CALIFORNIA ISO

Responses to Comments
from Stakeholders
On TEAM Analysis for PVD2

Set #2

California ISO
Department of Market Analysis & Grid Planning
February 11, 2005

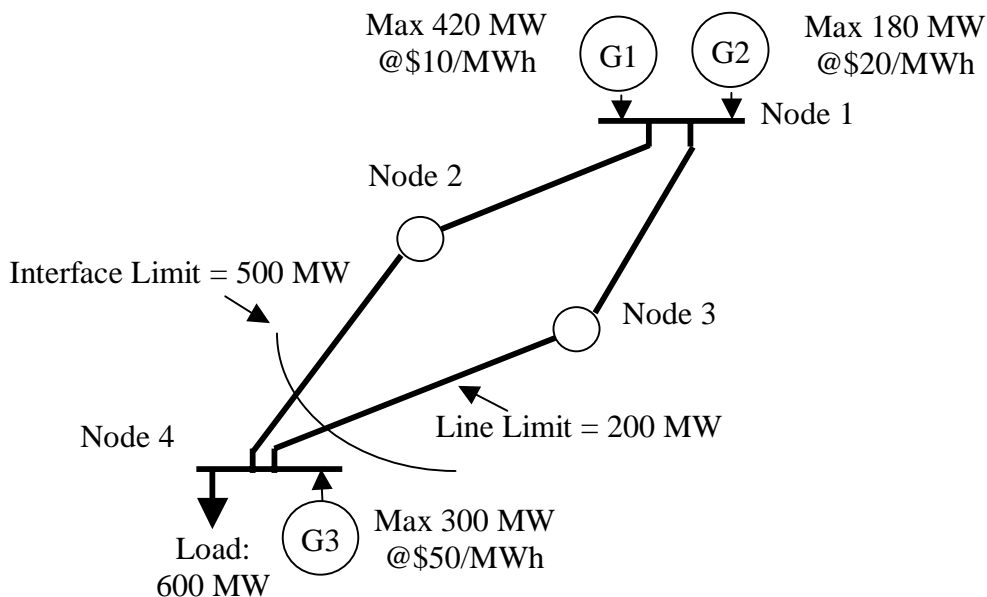
9. Does the congestion exist in both the full LMP model and the managed in real time model, but the costs are paid out of different pockets? That is what the text of the Draft Technical Appendix M seems to say: in the LMP version it is paid for through congestion revenues which are reverted to ISO customers (because they paid for it in FTRs?). In the real time management system, payment is through the uplift charge which is paid by (whom)?

At first I thought you were saying that the congestion revenues were a phantom of the full LMP model. Now it appears that the costs are real, but paid for differently. Thanks for your help in understanding the logic.

I'd really appreciate a simple graph or table of what congestion-related dollars are paid by whom in these 2 approaches.

It would be helpful to answer the question through an example as suggested:

Example:

Consider the following network with an interface limit of 500 MW and a transmission line limit of 200 MW on one of the lines comprising the interface. Assume all four transmission line segments shown have the same impedance. Nodes 2 and 3 are the boundary nodes between two control areas. The load is fixed at 600 MW (vertical demand), and

generation capacities and prices are as shown. Assume supply is bid at cost (no market power).

Forward scheduling and real-time dispatch with the physical network model

The line limit of 200 MW is more constraining than the interface limit. The minimum cost solution is: $G1 = 400$ MW, $G2 = 0$ MW, and $G3 = 200$ MW. The relevant LMPs are $LMP1 = \$10/\text{MWh}$ and $LMP4 = \$50/\text{MWh}$. The shadow prices are $\$0/\text{MWh}$ for the interface constraint and $\$80/\text{MWh}$ for the line constraint (a 1 MW increase in the line rating will allow displacement of 2 MW of $G3$ by 2 MW from $G1$ with a net dispatch cost reduction of $(\$50 \times 2 - \$10 \times 2 = \$80)$). The settlements are as follows:

- Cost to load: $\$50 \times 600 = \$30,000$
- Generation revenues: $\$10 \times 400 + \$50 \times 200 = \$14,000$
- Generation Cost: $\$10 \times 400 + \$50 \times 200 = \$14,000$
- Producer surplus: $\$0$
- Congestion rental: $\$80 \times 200 = \$16,000$

These schedules will be feasible so there is no need for real-time re-dispatch.

Forward scheduling and real-time dispatch with the contract path external model

Day-ahead scheduling based on the contract path external network model would allow specifying import schedules at nodes 2 and 3 without considering the impact of transmission from node 1. An equivalent way of saying this is that the SCs can schedule up to the interface limit of 500 MW by limiting their schedule at node 3 below 200 MW, and

scheduling the balance at node 2. In the day-ahead scheduling process, one may thus ignore the 200 MW line limit and enforce only the 500 MW interface limit. Accordingly, the minimum cost solution is: $G1 = 420$ MW, $G2 = 80$ MW, and $G3 = 100$ MW. The relevant LMPs are $LMP1 = \$20/\text{MWh}$ and $LMP4 = \$50/\text{MWh}$. The shadow price of the interface constraint is $\$30/\text{MWh}$. The day-ahead settlements are as follows:

- Cost to load: $\$50 \times 600 = \$30,000$
- Generation revenues: $\$20 \times 500 + \$50 \times 100 = \$15,000$
- Generation Cost: $\$10 \times 420 + \$20 \times 80 + \$50 \times 100 = \$10,800$
- Producer surplus: $\$4,200$
- Congestion rental: $\$30 \times 500 = \$15,000$

The day-ahead schedules are not feasible in real-time since with 500 MW generated at node 1, there will be a flow of 250 MW on the line from node 3 to node 4. So, real-time re-dispatch will be required. It will involve DEC'ing $G2$ from 80 MW to 0 MW, and $G1$ from 420 MW to 400 MW, and INC'ing $G3$ from 100 MW to 200 MW. Depending on whether the settlement in real-time is as bid or based on LMPs. The settlement may be as follows:
